Detailed Site Plan

DSP-21013

Broad Creek Townhouses at Henson Creek

STAFF REPORT

Figure 1: Site Plan

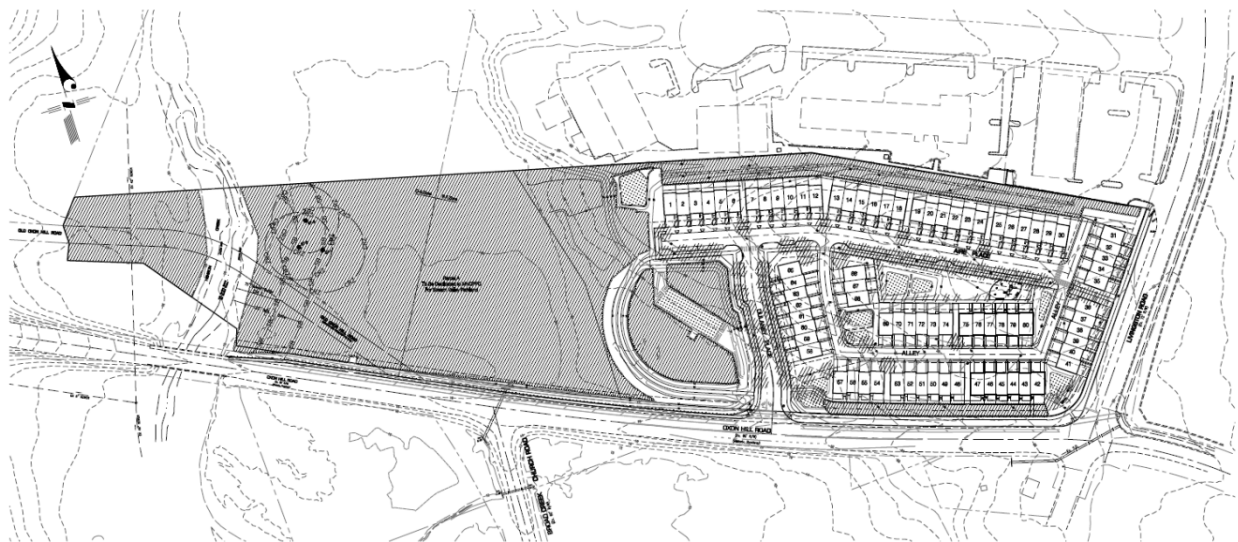
6. **Design Features:** This DSP application includes 80 single-family attached dwelling (townhouse) units and has one vehicular access on Oxon Hill Road. Within the property, two private roads, Dulaney Place and Aire Place, form the primary vehicular circulation of the site and provide access to 38 front-loading units. The other 42 units are rear-loading and are served by alleys. Sidewalks are located on both sides of Dulaney Place and Aire Place and within both Oxon Hill Road and Livingston Road frontages. Additional sidewalks are located in front of the rear-loading units, between Lots 35 and 36, and around the stormwater management (SWM) facility on Parcel H. A 6-foot-wide bike lane is located along the northern side of Oxon Hill Road. However, the road section of Oxon Hill Road shows only 5 feet for this bike lane, which is conditioned herein for correction.

Figure 3: Playground Layout

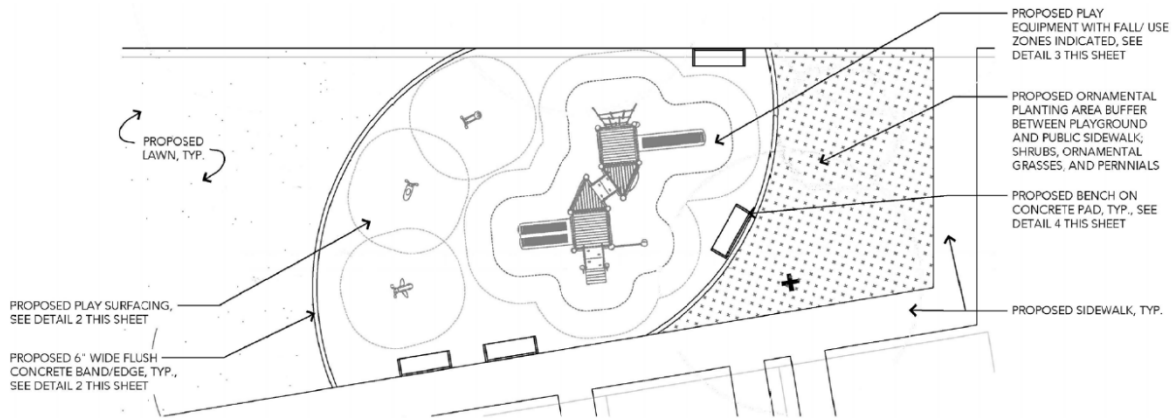
An open area (Parcel G) is surrounded by the proposed townhouse units, in which the applicant provides a playground that includes a tower/slide structure and three spring animals. Four benches and two bike racks are provided around the playground. Two benches are also located at each end of the 6-foot-wide walkway around the SWM facility on

Parcel H. Two dog waste stations are included in this DSP application, one located near the playground and the other located at the west end of Aire Place.

Figure 4: Gateway Sign Details

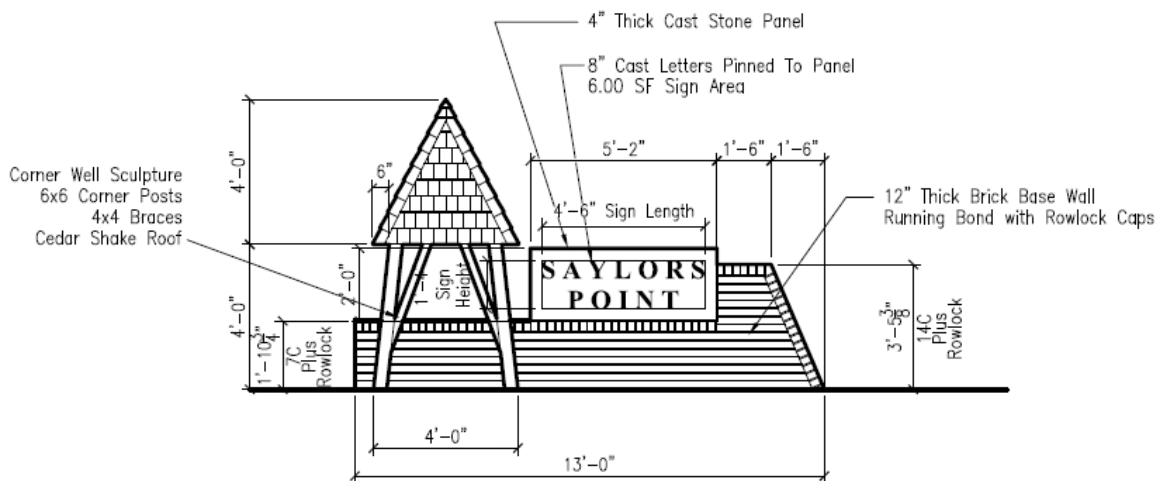
The submitted photometric plan demonstrates that the internal roadways and public areas of the site are adequately lit, and such light will not spill off-site. The luminaire schedule in the photometric plan shows a total of 12 light fixtures for this DSP, and yet 13 fixtures are shown on the plan. A condition is included herein requiring the applicant to correct the total number of light fixtures. One gateway sign is proposed for this DSP and it is located at the northwest corner of Oxon Hill Road and Livingston Road, with a height of approximately 4 feet. This gateway sign is designed with a well sculpture, to remember the well previously located at the door of the historic St. John's Church, not only serving as an identifier for the proposed development, but also as a reminder of the Broad Creek Historic District across Oxon Hill Road.
